## Holes rev 3

TRIUMF tasks:

DOOR view from outside

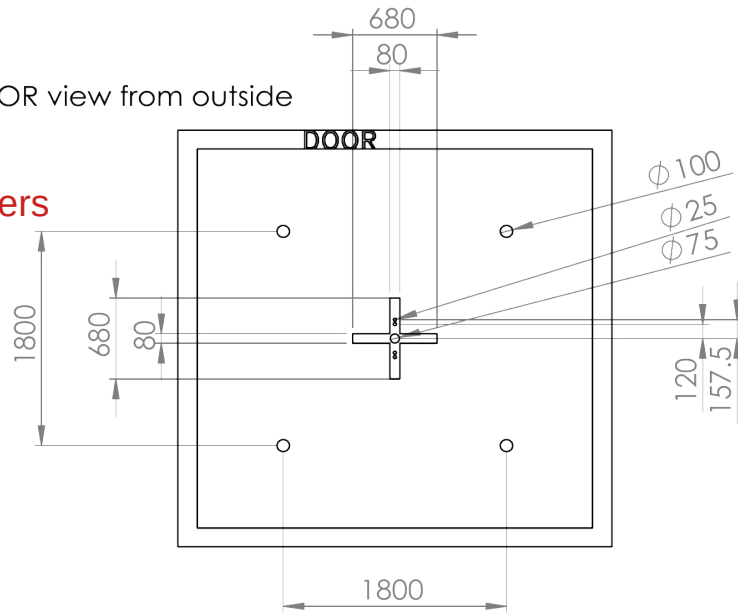
Through-holes:  
4x 100mm corners  
4x 25mm  
1x 75 center

DOOR view from inside  
150mm and 180mm holes on inner layer only

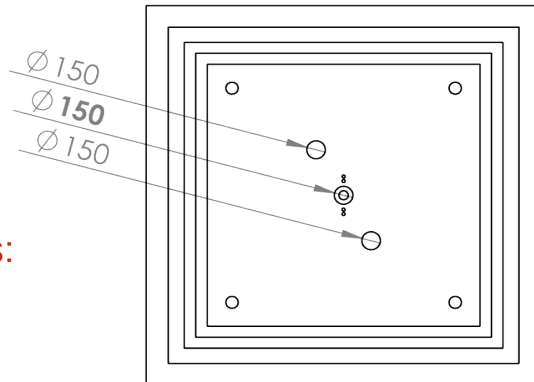
Inner layer holes:  
3x 150mm

REAR view from outside

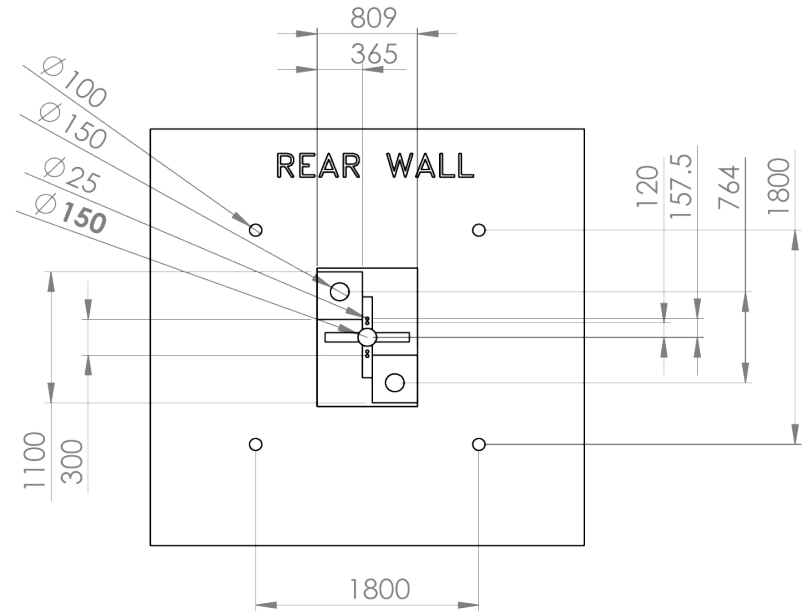
- MSL to redesign REAR panel support due to conflict with large non-central holes
- What are the dimensions of the panel on REAR wall?
- Check picture frame design and revised holes?  
→ flexibility to locate outside frame
- Frame concept design available?
